**FINAL DRAINAGE REPORT
FOR
SOLACE AT CIMARRON HILLS**

**March 12, 2021
Project No. 25174.00**

**PCD File No. PPR-20-047
PCD File No. SF2032**

DETENTION BASIN OUTLET STRUCTURE DESIGN

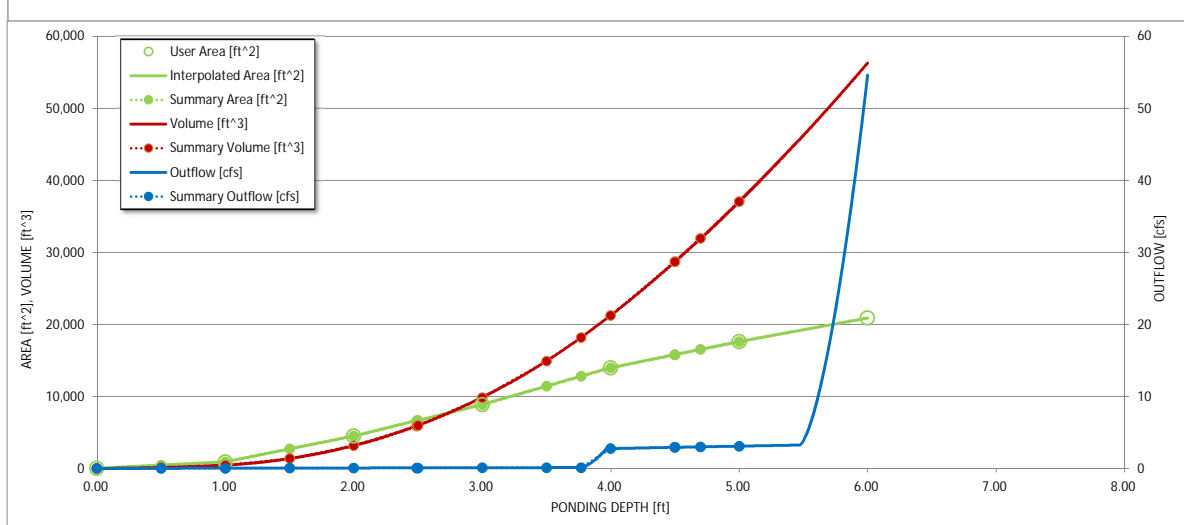
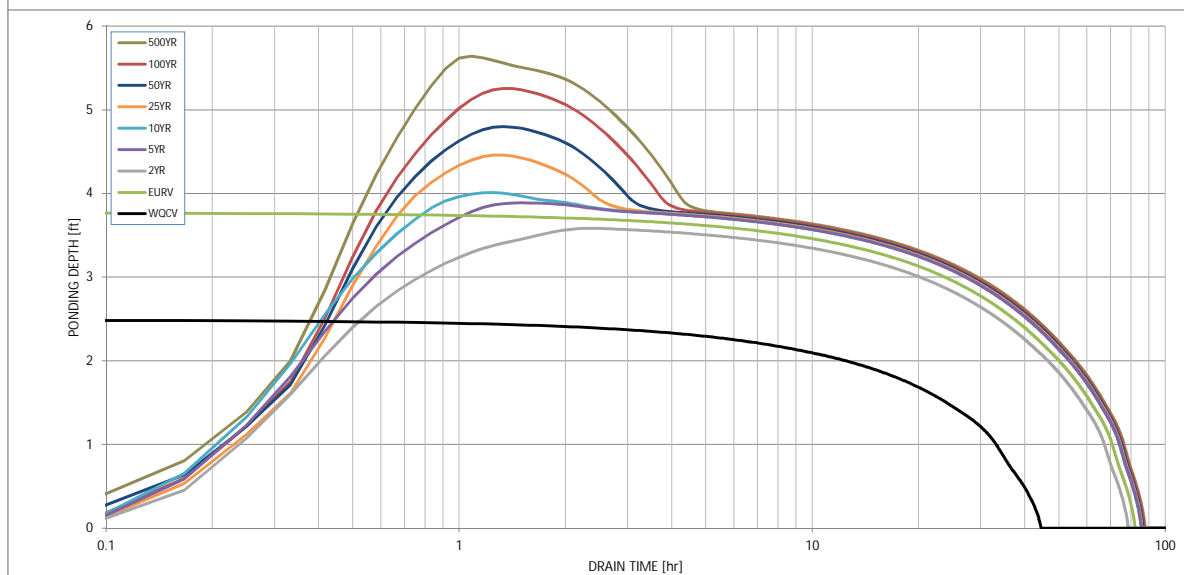
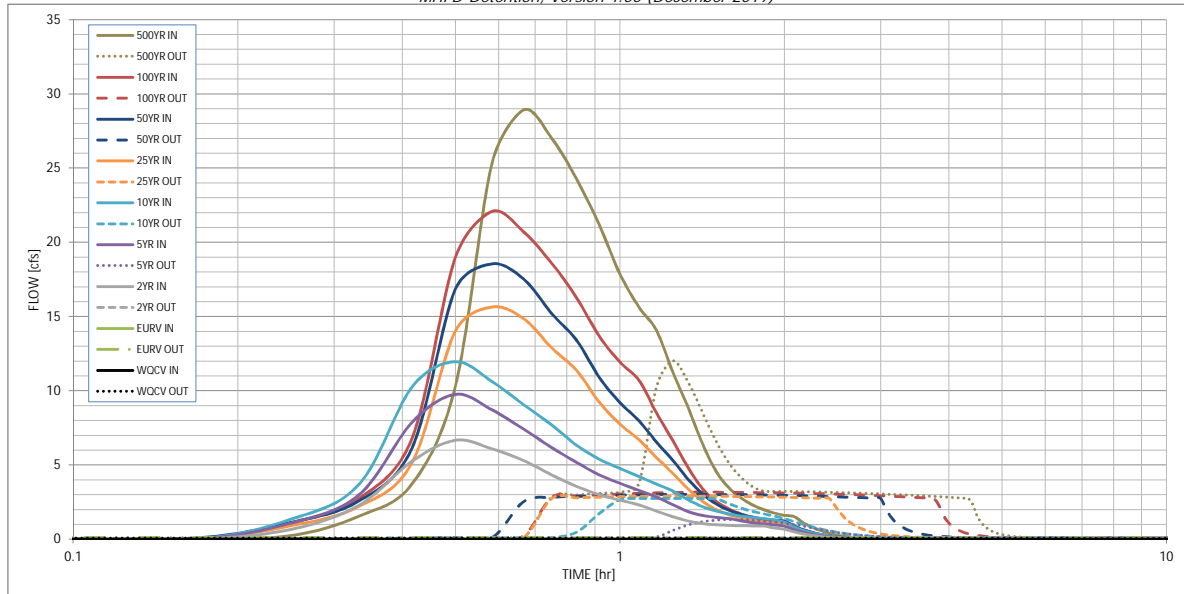
Revise to design drain time to be within 40 hours for extended detention basins per state statute 15-212.

Drain time revised. Orifices updated accordingly.

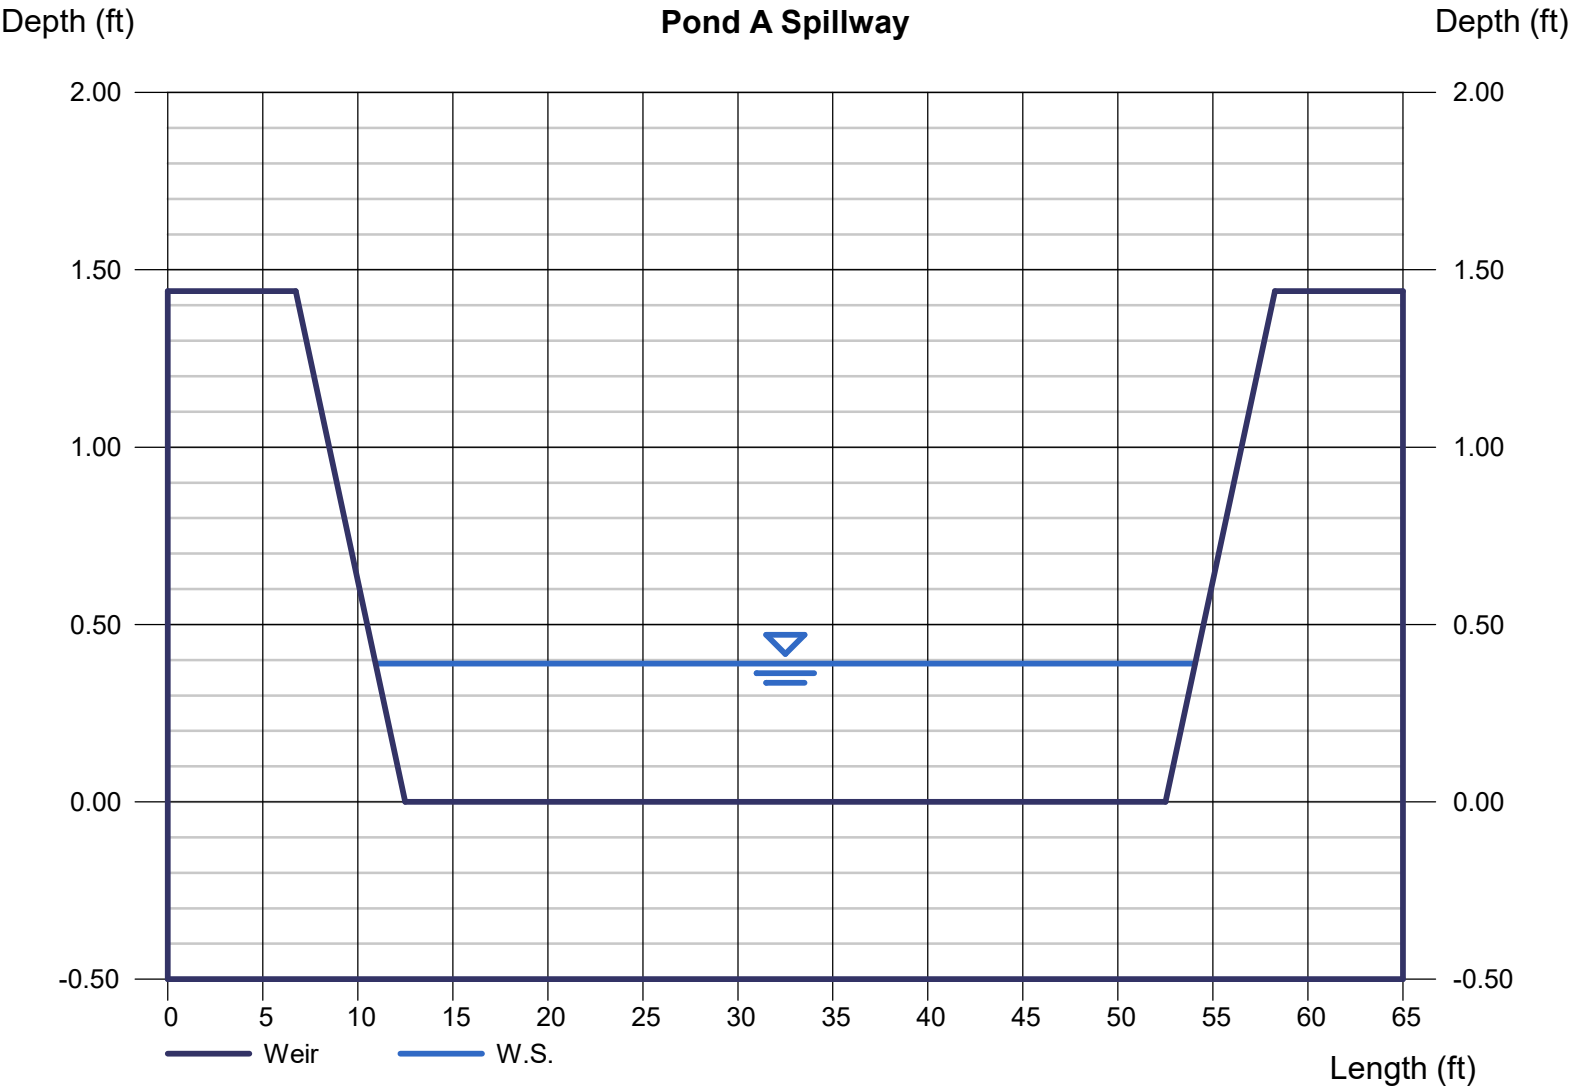
Side slopes are 10% in all other documents. Revise to remove inconsistencies.

Section revised to match what is shown and Basin Outlet Structure sheet.

DETENTION BASIN OUTLET STRUCTURE DESIGN

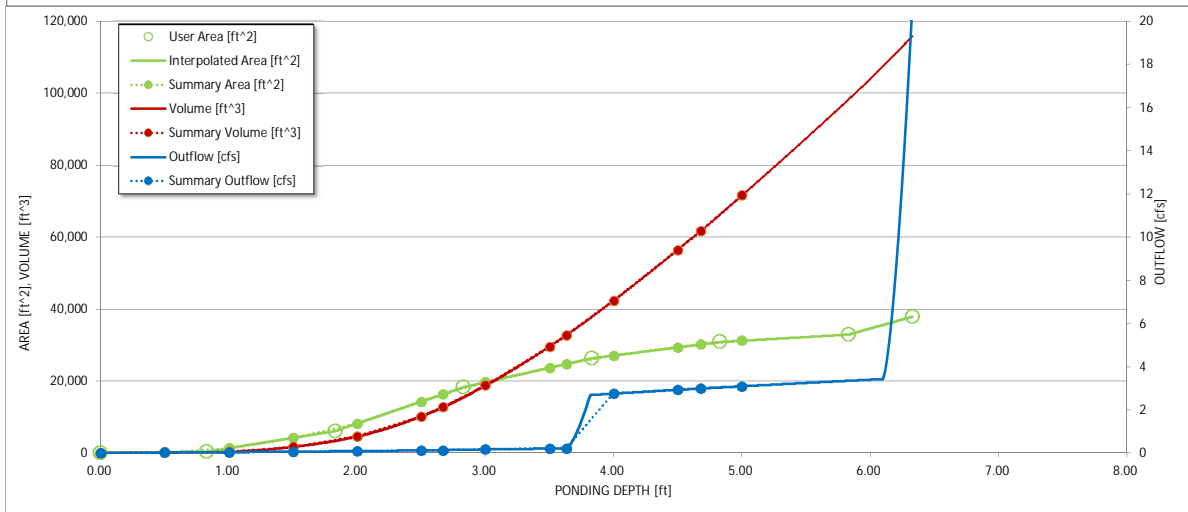
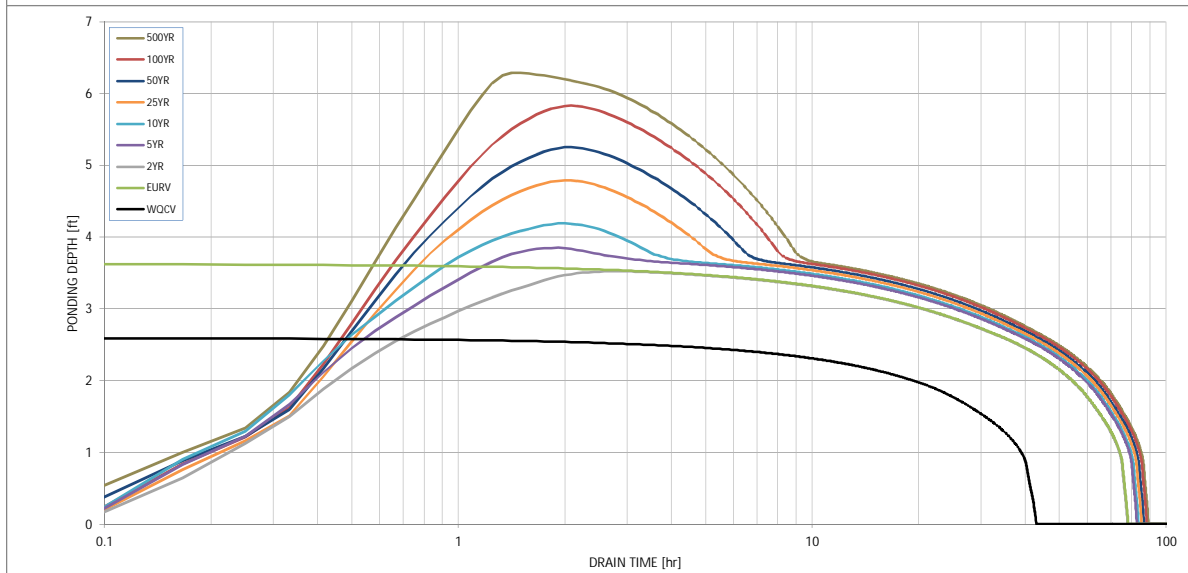
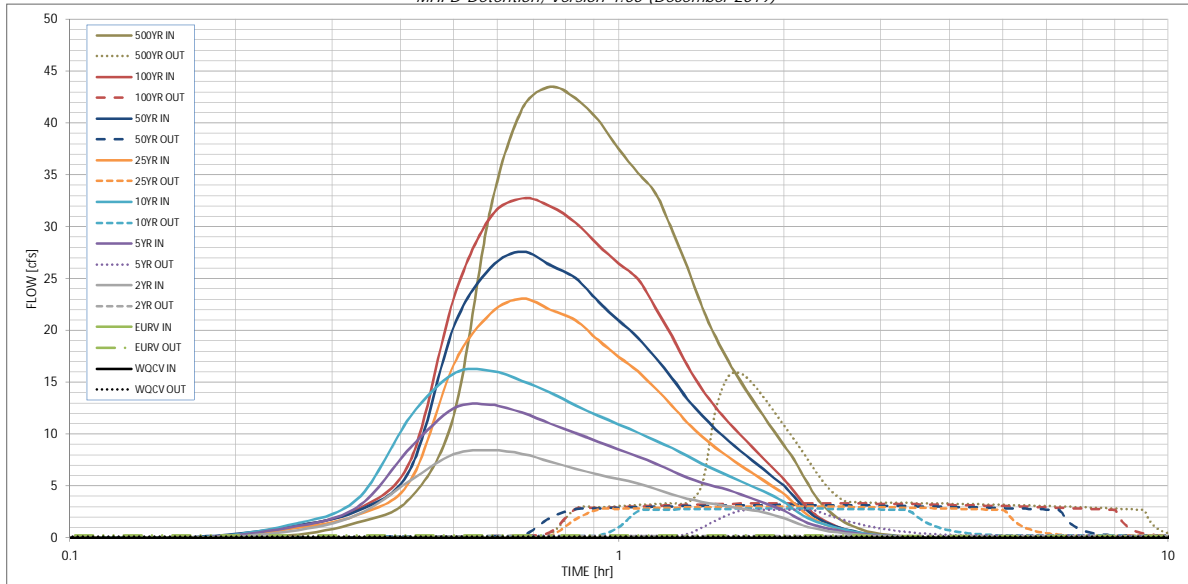
Revise to design drain time to be within 40 hours for extended detention basins per state statute 15-212.

Design Revised to drain within 40 hours

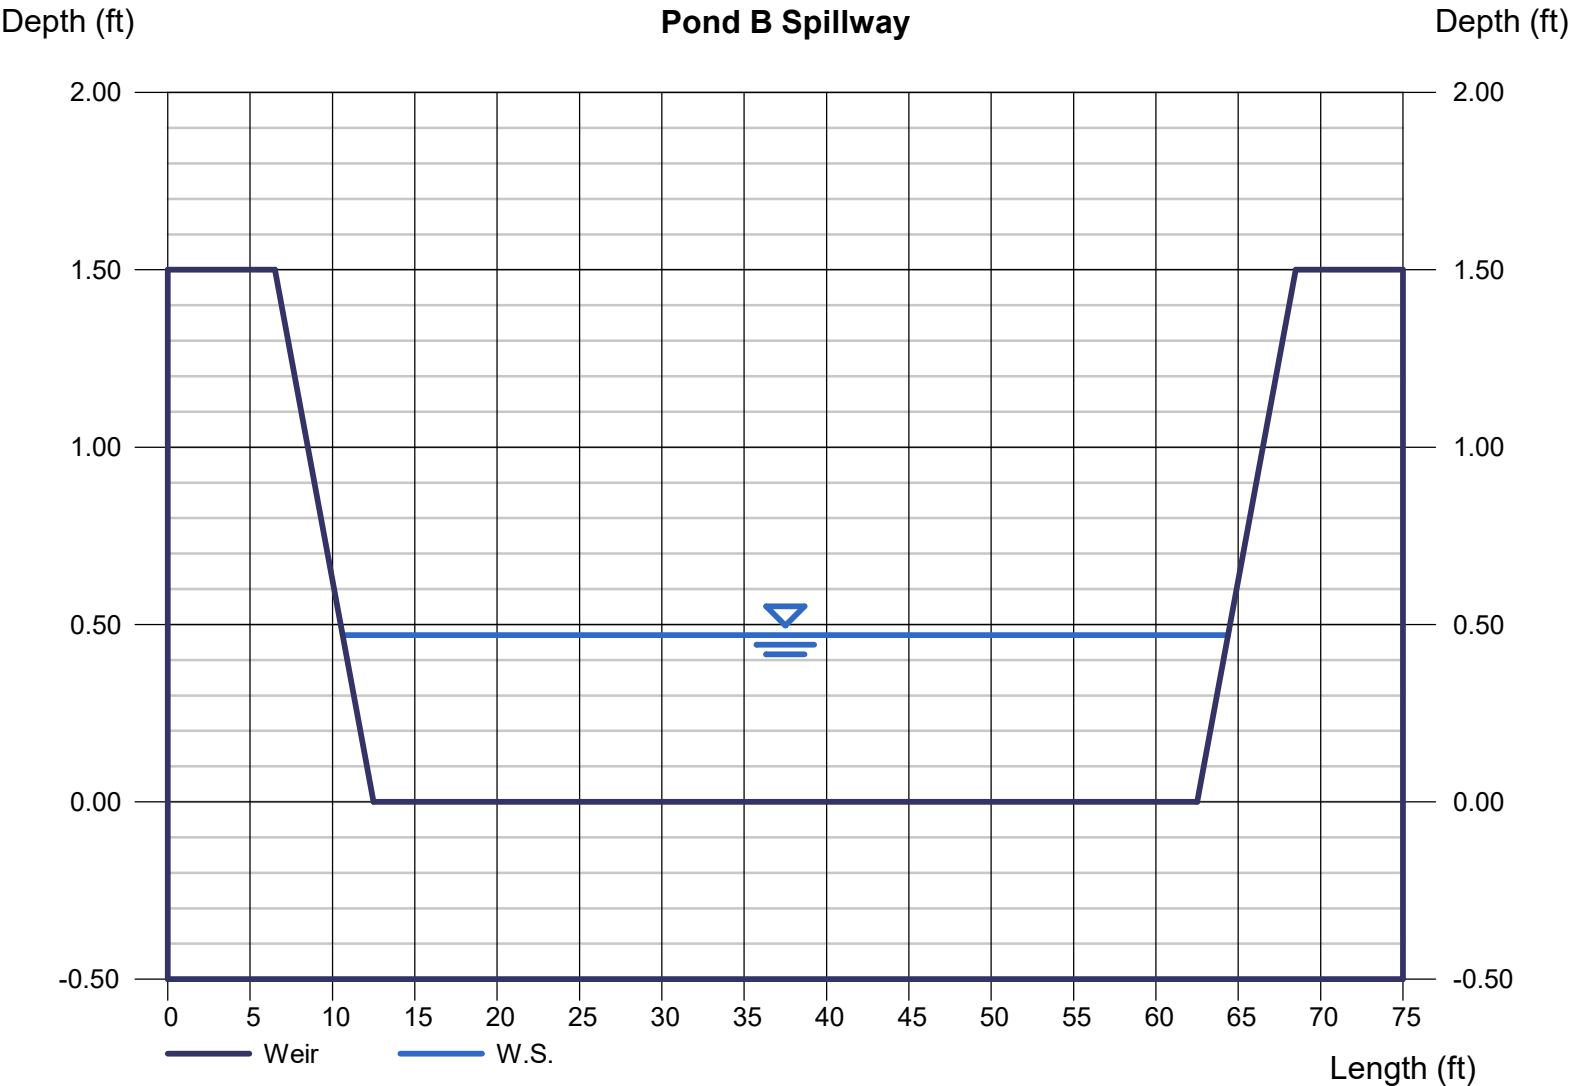
Side slopes are 10% in all other documents. Revise to remove inconsistencies.

Section revised to reflect what is shown on the Basin Outlet Structure
